Re: A & J Cartage Site Plan Review letter dated January 19, 2022

Re: A & J Cartage Site Plan Review letter by SAFEbuilt dated January 20, 2022

Re: A & J Cartage Site Plan Review No. 1 dated January 19, 2022

SITE PLAN FOR A & J CARTAGE

TITLE: SITE PLAN & LANDSCAPE PLAN

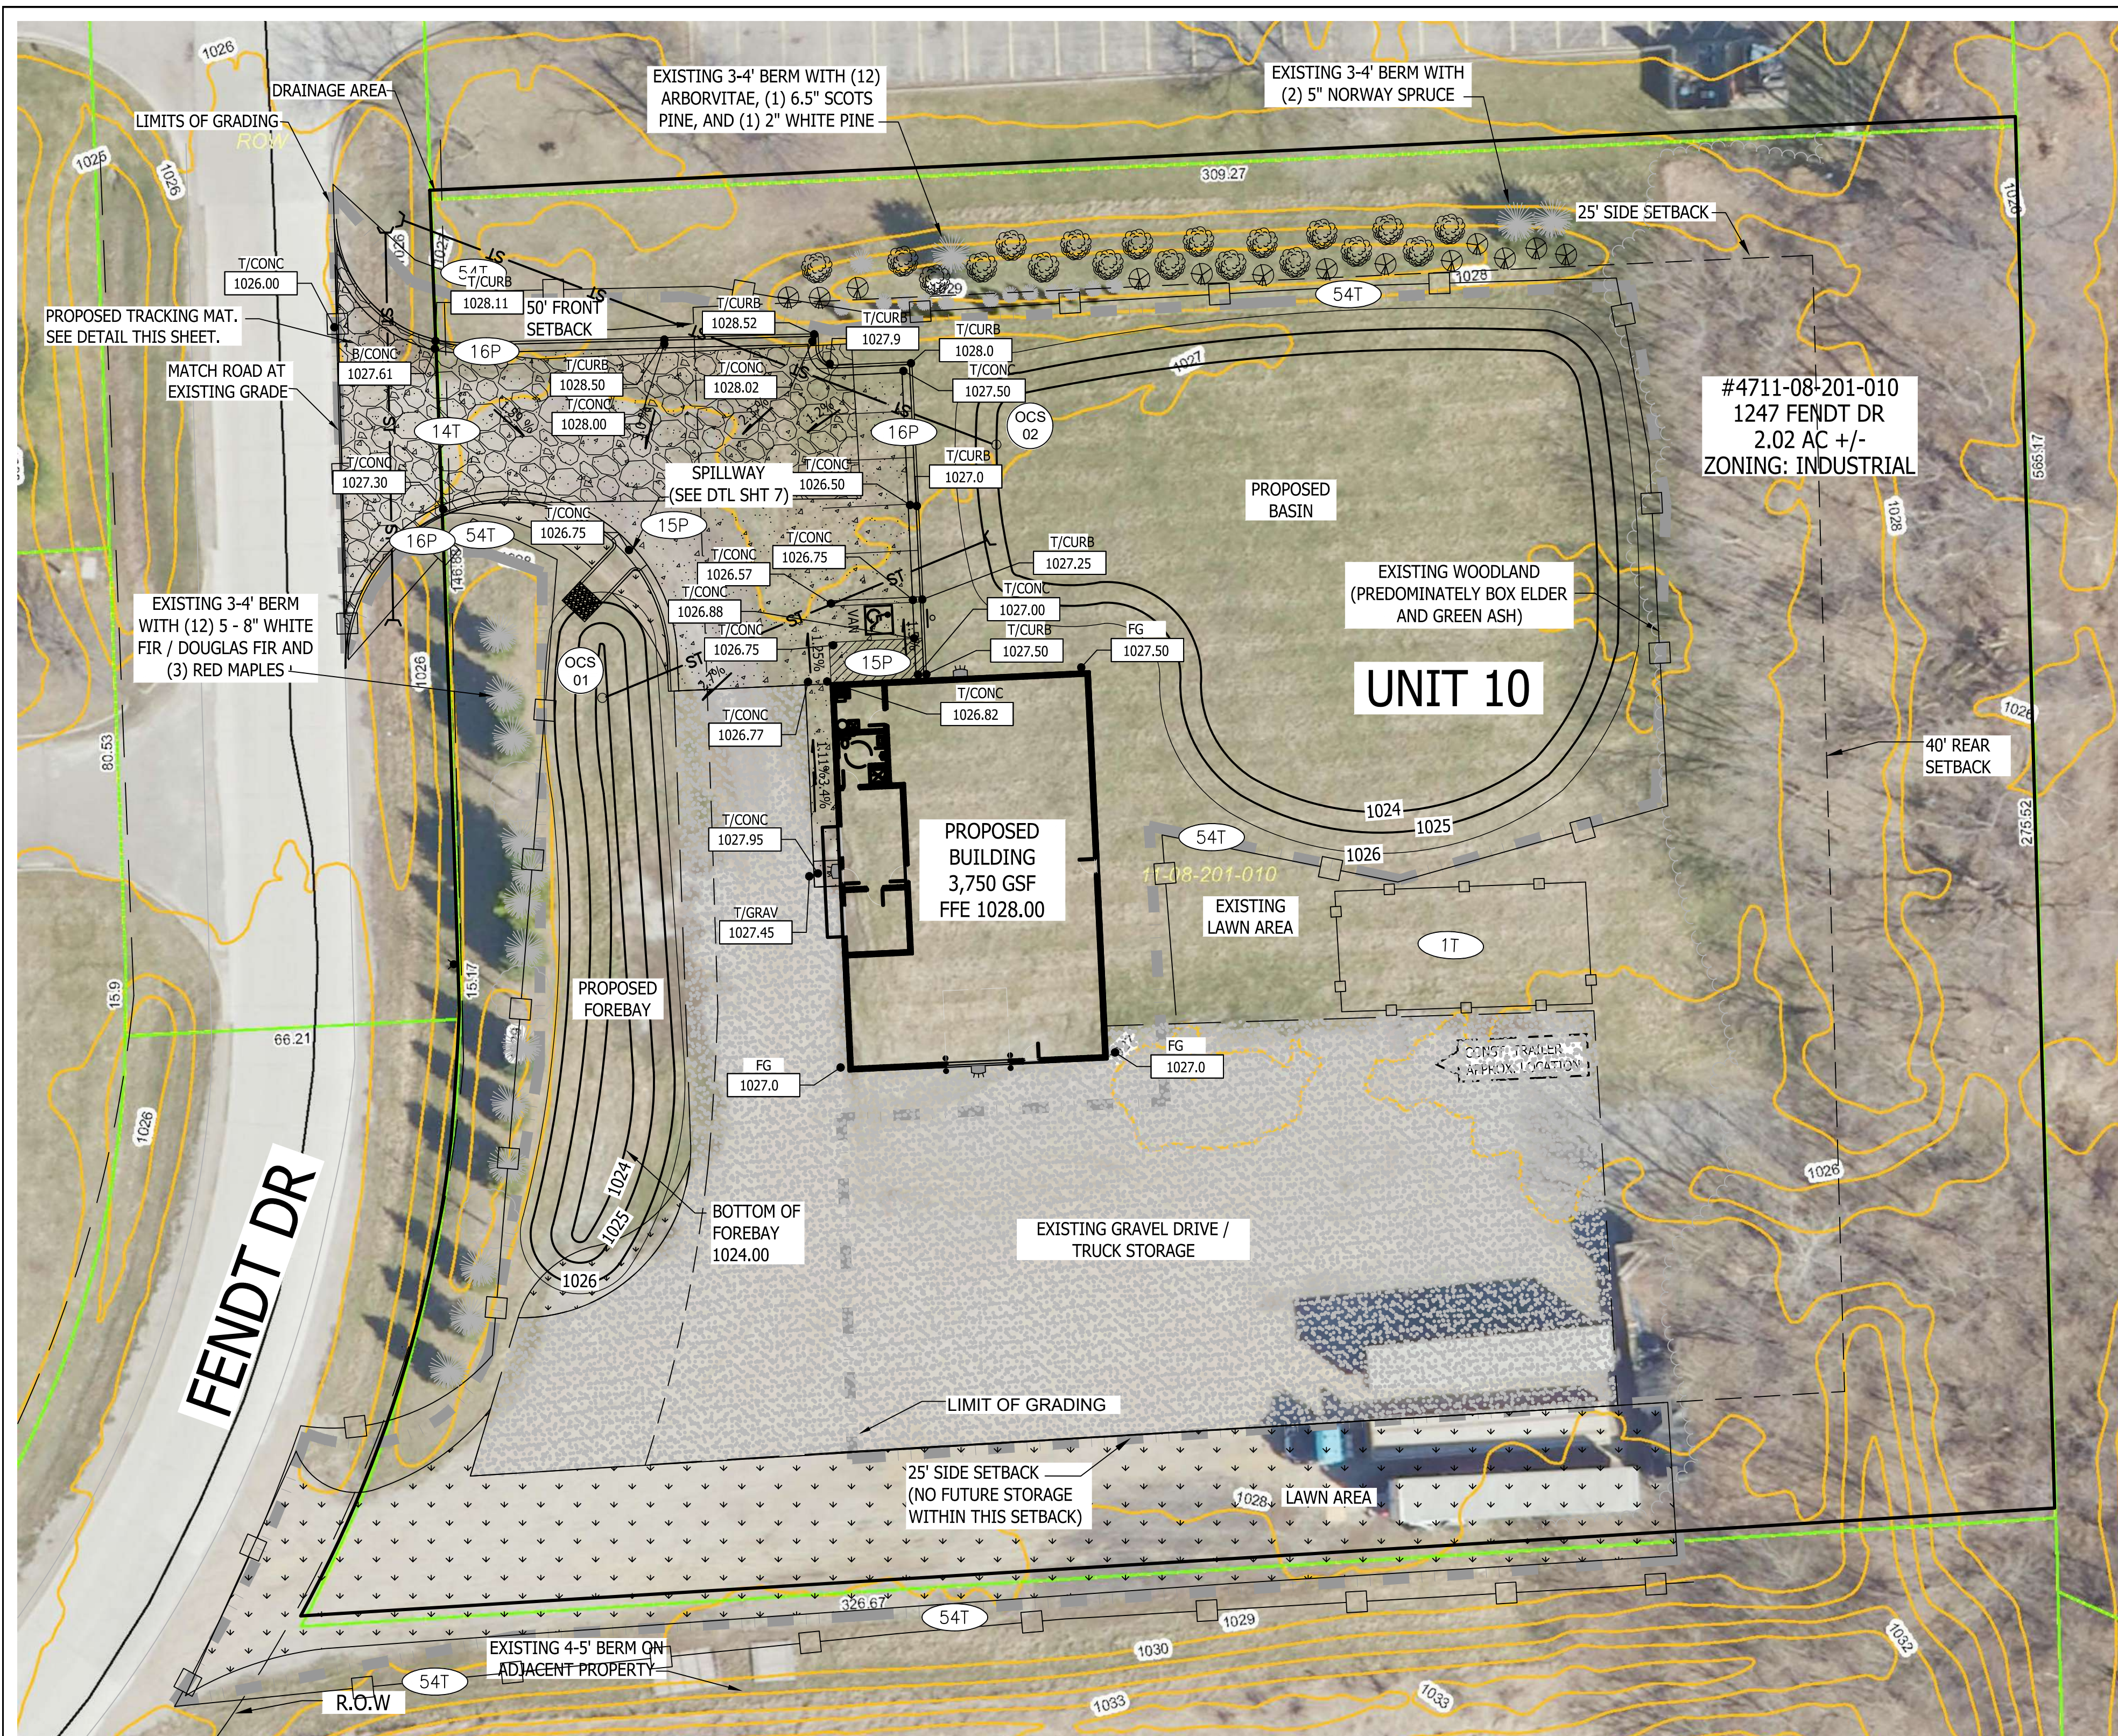
1. Acknowledged.
2. A note regarding building address and letter height can be found on the Site Plan Sheet 3.
3. Building-mounted fire lane signs have been added to the Site Plan Notes on Sheet 3 and a detail of the sign has been added to Construction Detail Sheet 7. A note regarding access roads during construction has been added to the Grading, Drainage and SESC Sheet 4.
4. A note regarding the location of a Knox Box can be found on the Site Plan Notes Sheet 3.
5. Acknowledged. These requested names will be available when selected by the Owner.

2. The impact statement information has been added to the Site Plan Sheet 3 under Impact Statement Notes. Approximately 20 gallons of motor oil for routine maintenance of a tractor trailer will be stored in the proposed building, in addition to typical tractor trailer maintenance materials and equipment.

4. No outdoor storage will be within the required 25-foot side yard setbacks nor any other required yard setback (See note on Site Plan Sheet 3.)
6. An additional tractor-trailer truck turning template has been added to Circulation Plan Sheet 6 as requested to demonstrate truck maneuvering on-site.

8. The height of tractor trailers to be stored outdoors are typically 13.5'. A note with this information has been added to Site Plan Sheet 3 Notes.

1. Calculations for Impervious surface lot coverage 31 % (0.62 acres). This information has been added to Site Details on the Site Plan Sheet 3.
2. More details regarding building materials are indicated on the Architectural drawings in this resubmittal. See Drawings by Others at the end of the drawing set. In addition, samples of proposed materials will be presented at the Planning Commission meeting.

4. Acknowledged
5. Parking calculations have been adjusted to industrial use as required. 6 spaces are provided. See Site Plan Sheet 3.
6. See the response to #7 Use Conditions above.
7. Light fixtures have been changed to full cut off lights. See the revision on Sheet 6.
8. Waste generated at this site is minimal and typically disposed of off-site by owner. Should it become necessary, curbside pickup would be utilized.

TITLE: GRADING, DRAINAGE, & SESC PLAN

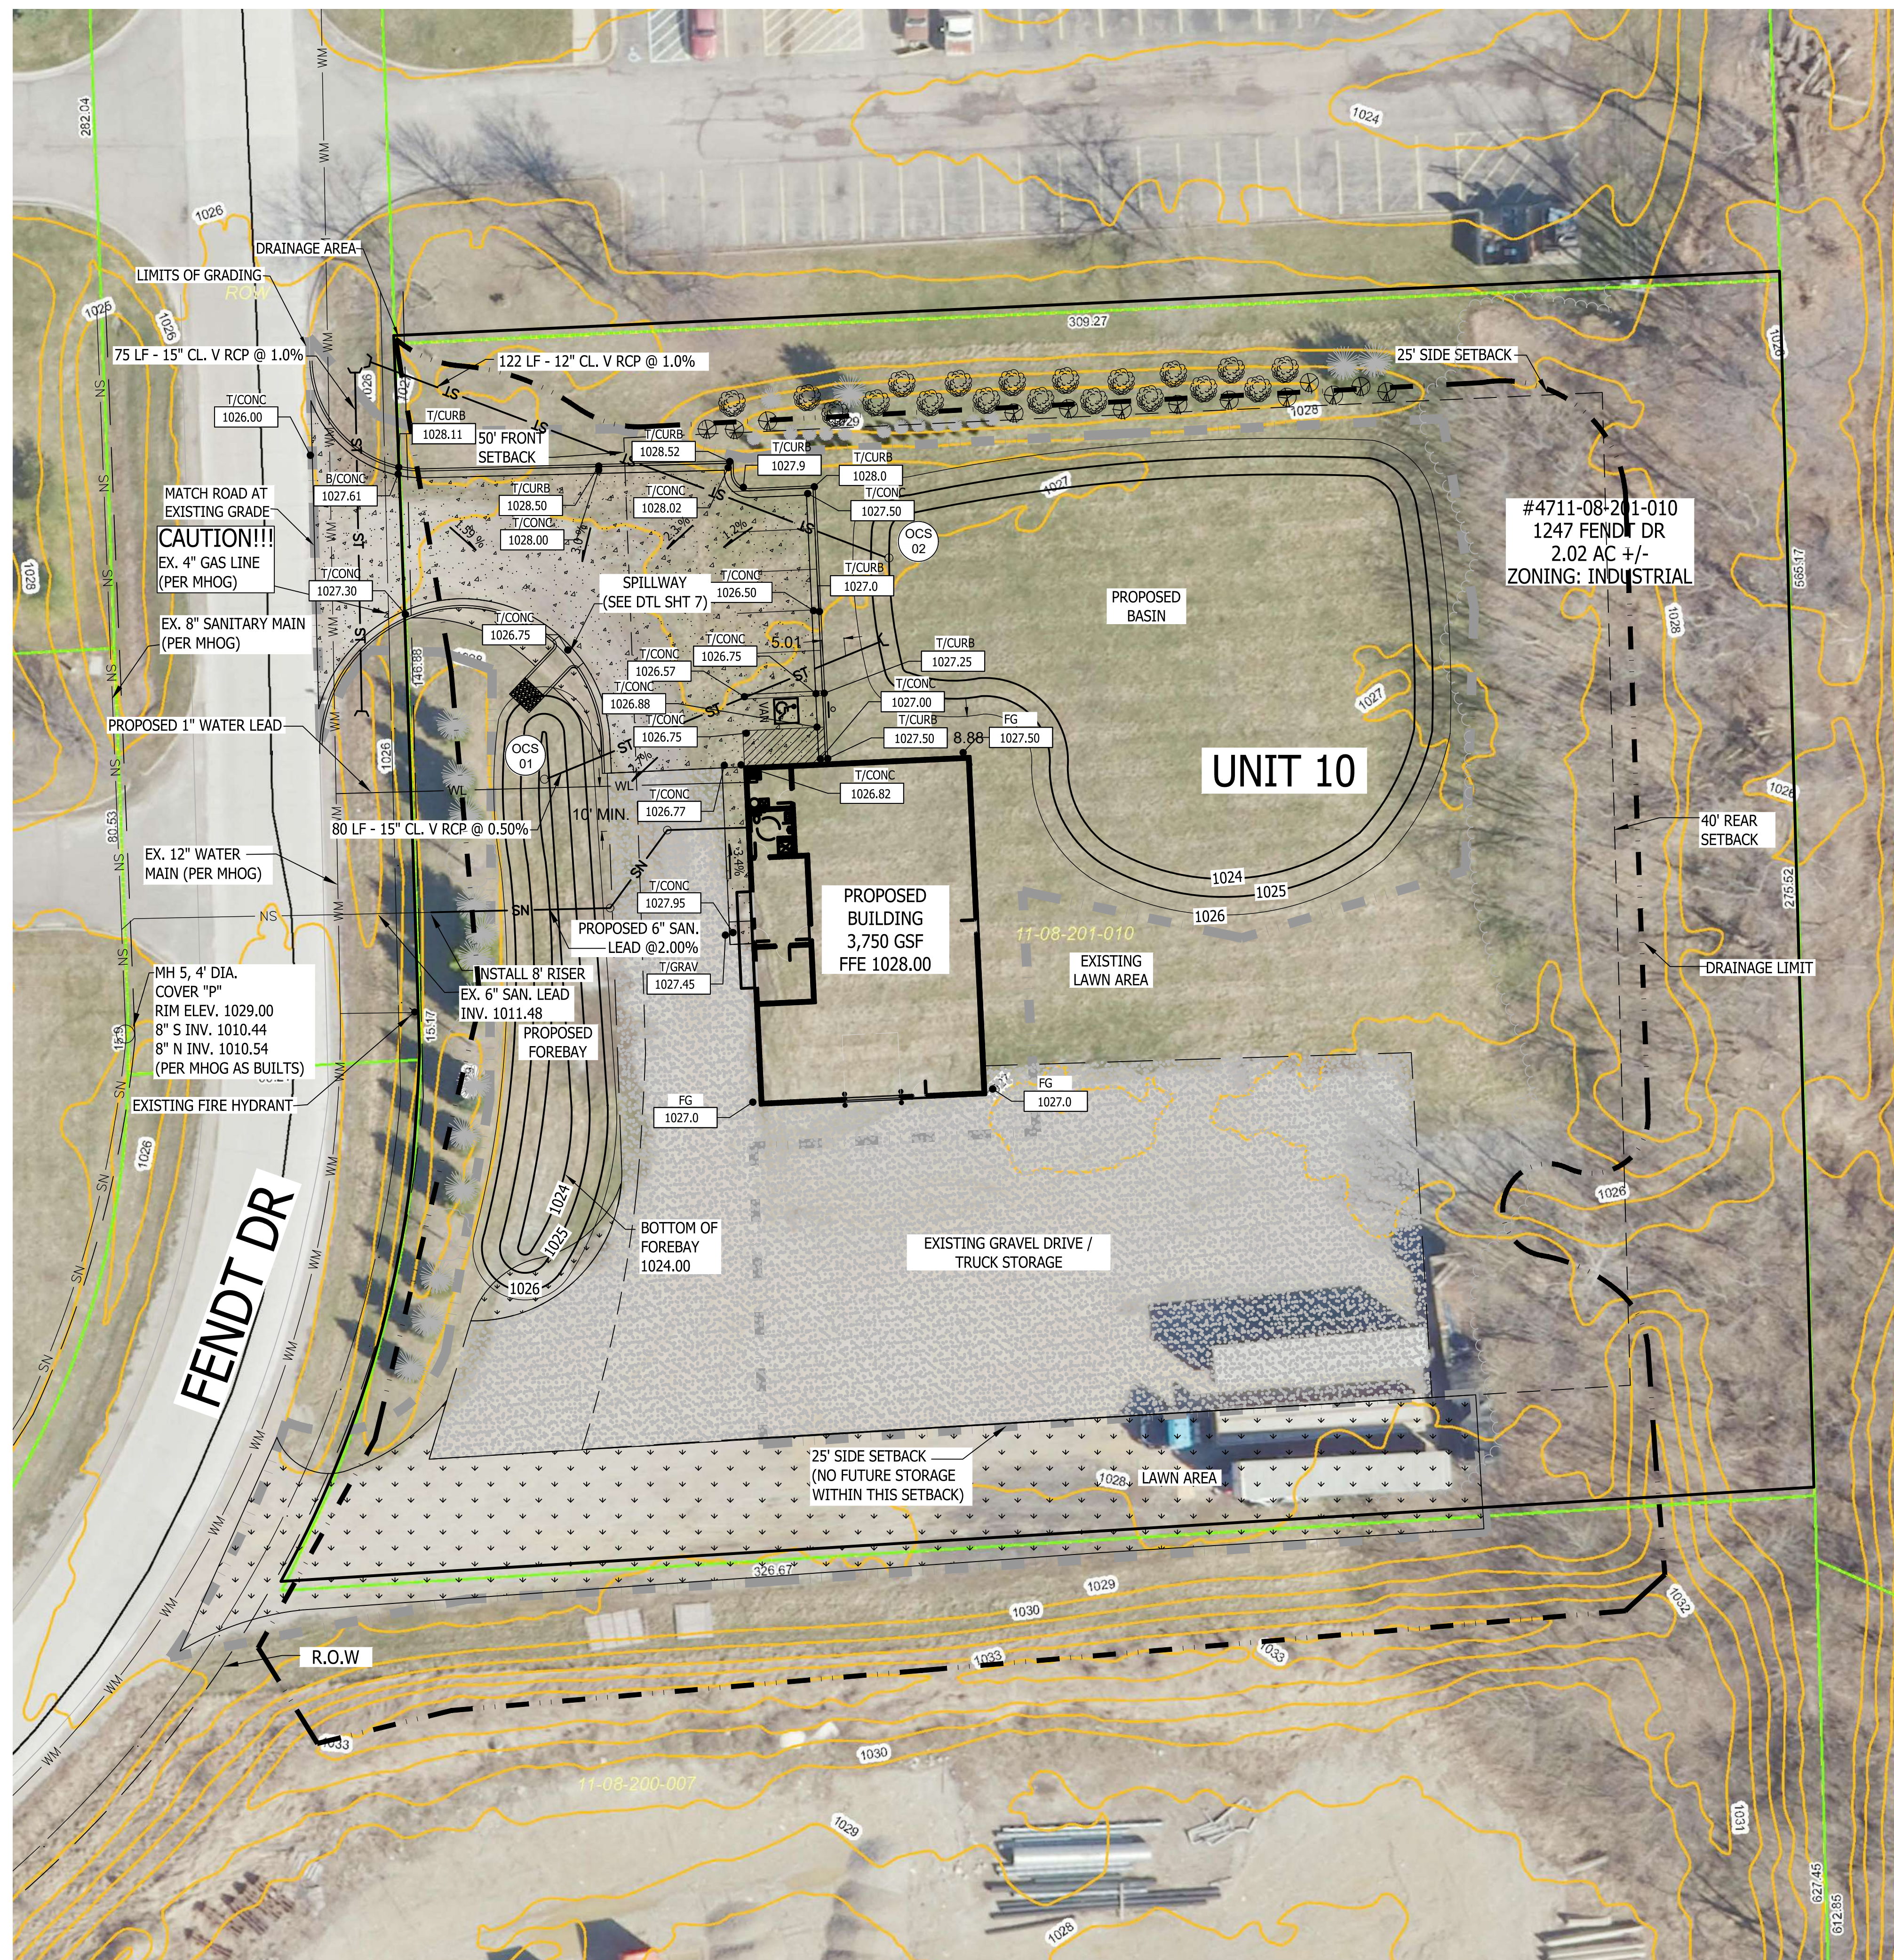
5. The Grading Plan Sheet 4 has been updated with additional grades to show positive drainage.
6. MHOG Water and Sewer details have been added to drawing set on Sheet 8.
